ENERGY STAR Display Specification 6.0 Draft 1
Comments from the European Commission

We provide in the following comments from the European Commission to the Product Specification for Displays – Eligibility Criteria – Draft 1 Version 6.0. We generally appreciate and support the contents of the document.

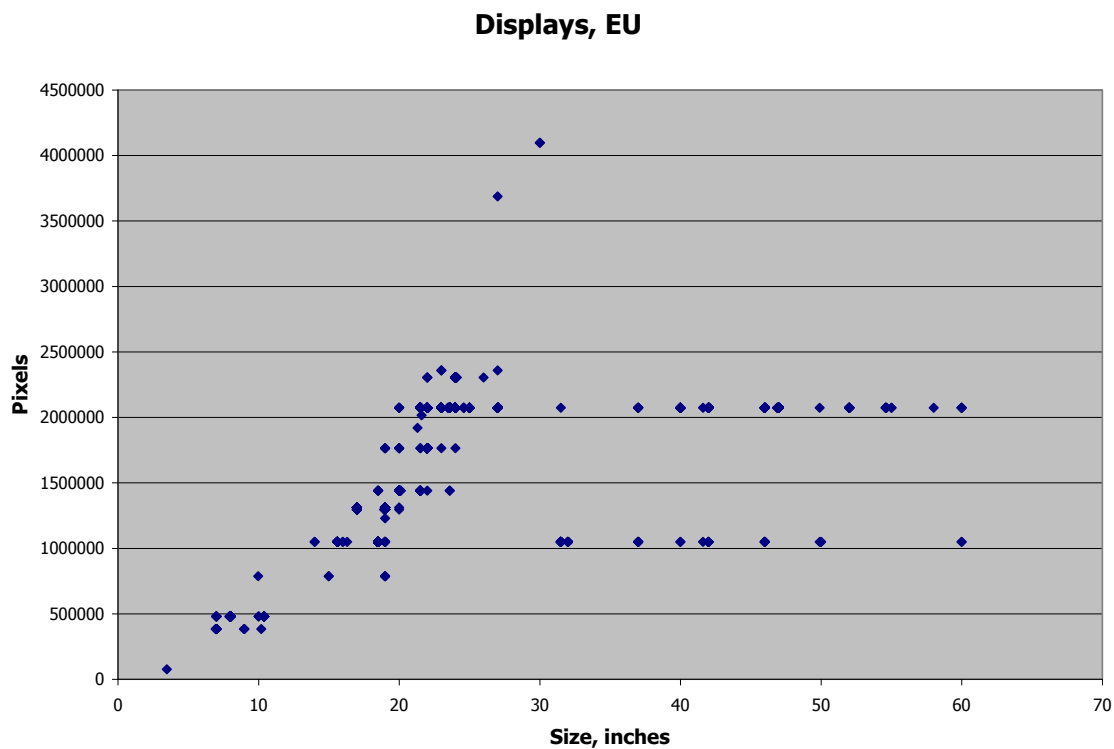
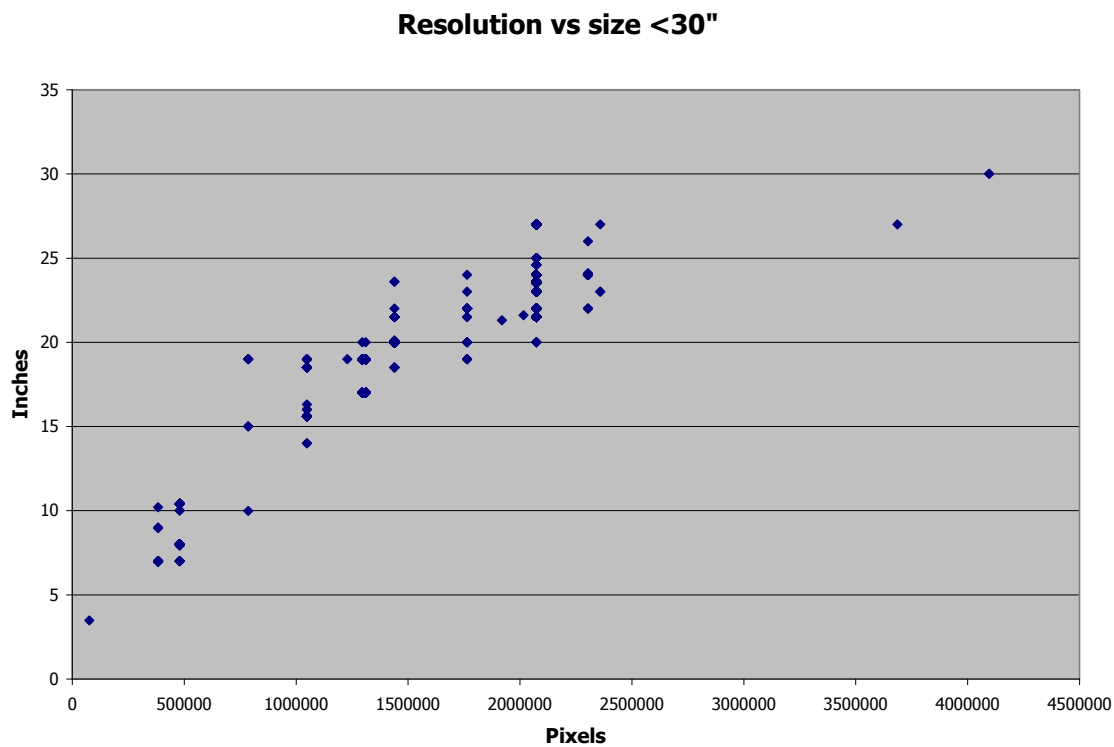
Line 177 – Calculation of on mode power for ABC products: For office use of displays the light levels are typically around 200 lux most of the time (the required level in some countries) and here the formula is too skewed towards the low end. This results in measured values, which are lower than real use value. For household use the formula might be more correct.

The formula might need to be adjusted e.g. to have at least 75 % weighting totally at 150 and 300 lux. In addition, we believe that the light source, test configuration etc. may have high impact on how the ABC regulates the luminance of the display.

A survey might be made of the actual lighting conditions in offices and homes, where most displays are used.

Displays, EU

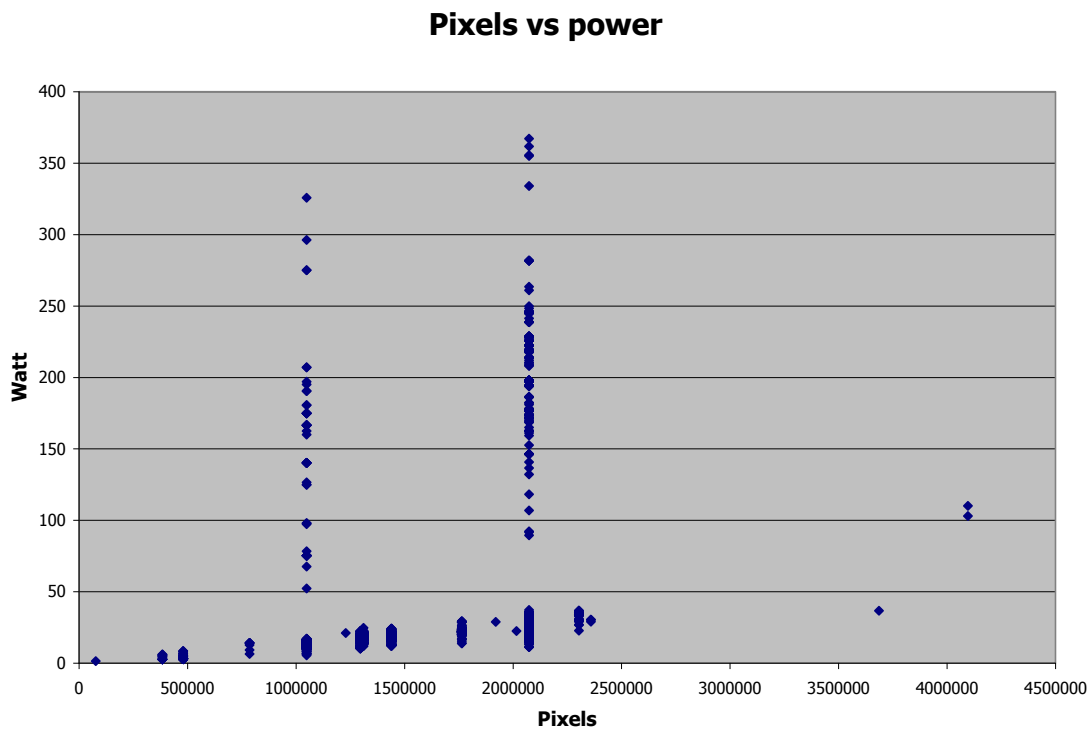
Line 244 – Screen resolution: We have made an analysis of the product data from the EU database, which we describe in the following.

Data has been arranged and filtered (various null-data omitted), and a diagram with the relation between size and resolution has been made. The diagram clearly shows that the resolution to a very high degree depends on the screen size for this data-set. The bigger the screen, the higher the resolution. The following diagram shows the whole filtered dataset:

Resolution vs size <30"

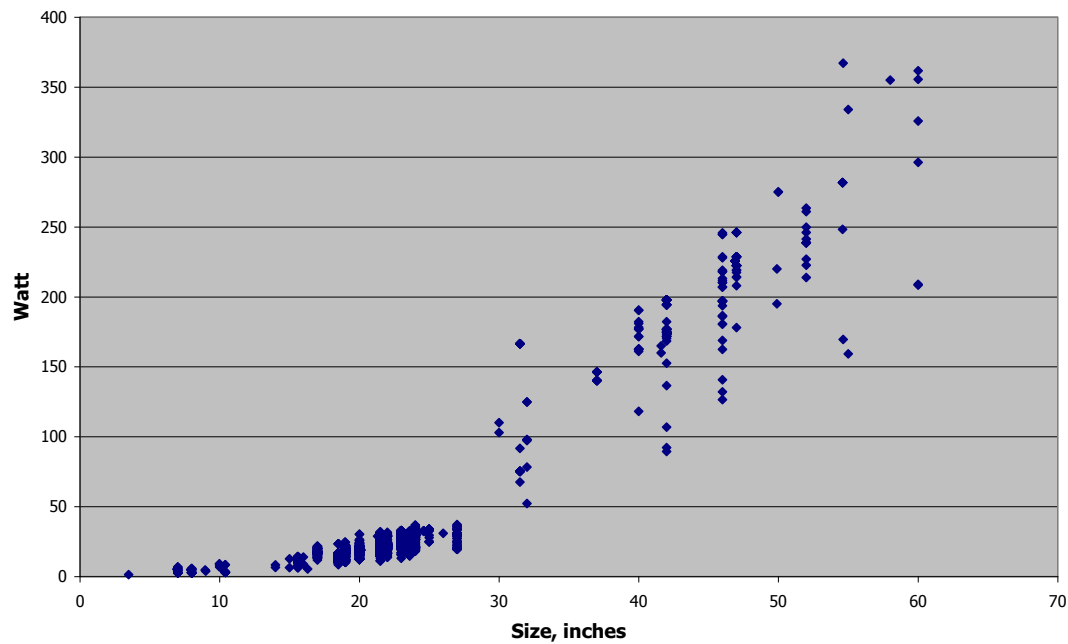
Below, the data-set is shown without the display sizes above 30 inches, and with resolution as x-axis:

Pixels vs power

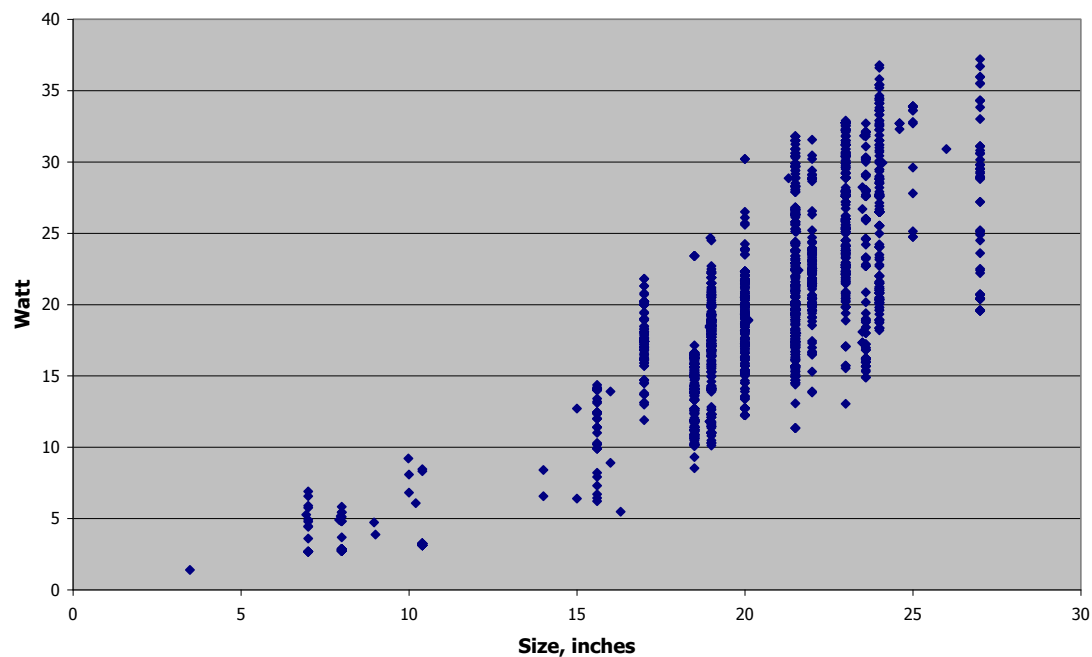
Below is the power for all screen-sizes shown according to the resolution. It is quite clear that a certain reso-lution can have a wide variety of power consumptions.

Size vs Power

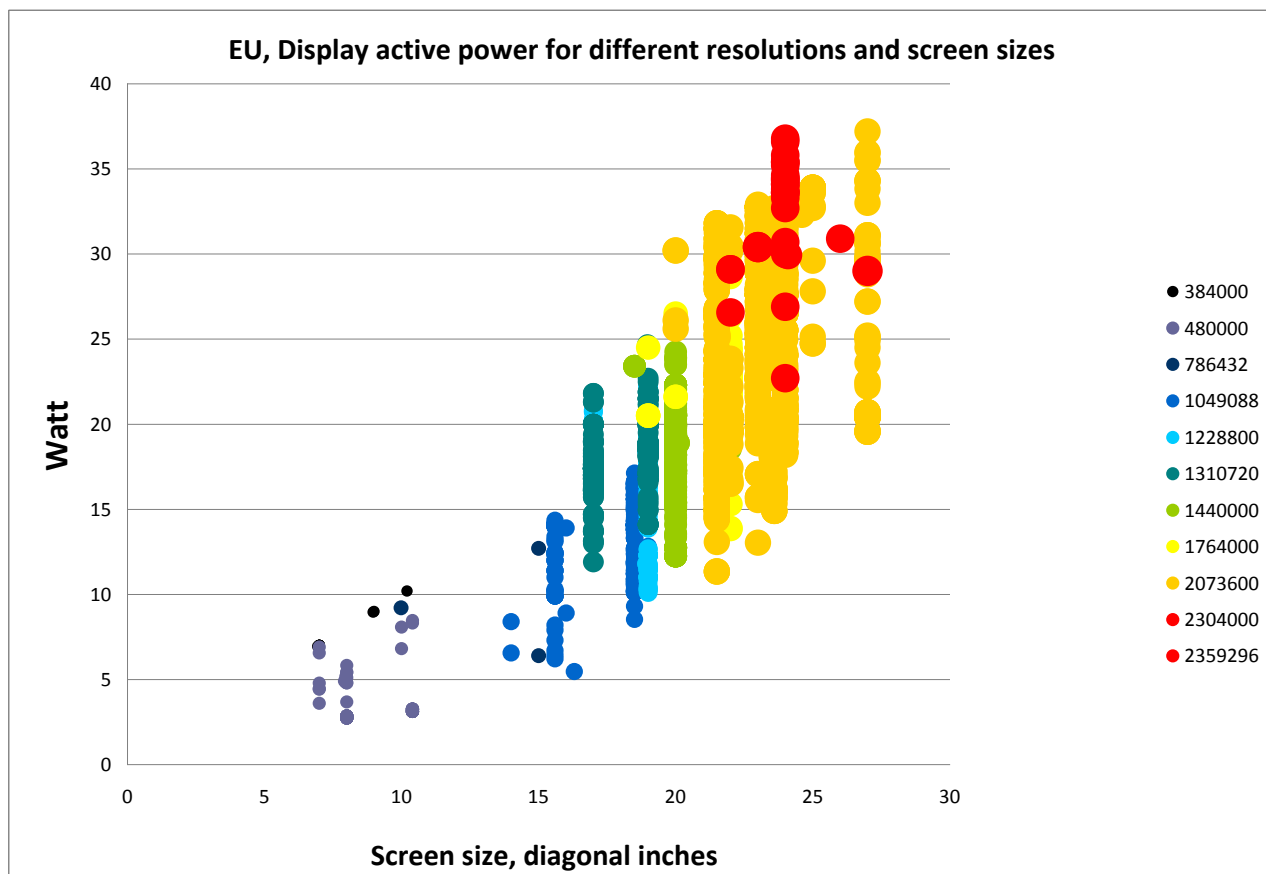
In contrast to the above diagram, the following diagram below shows a very good correlation between screen size and power:
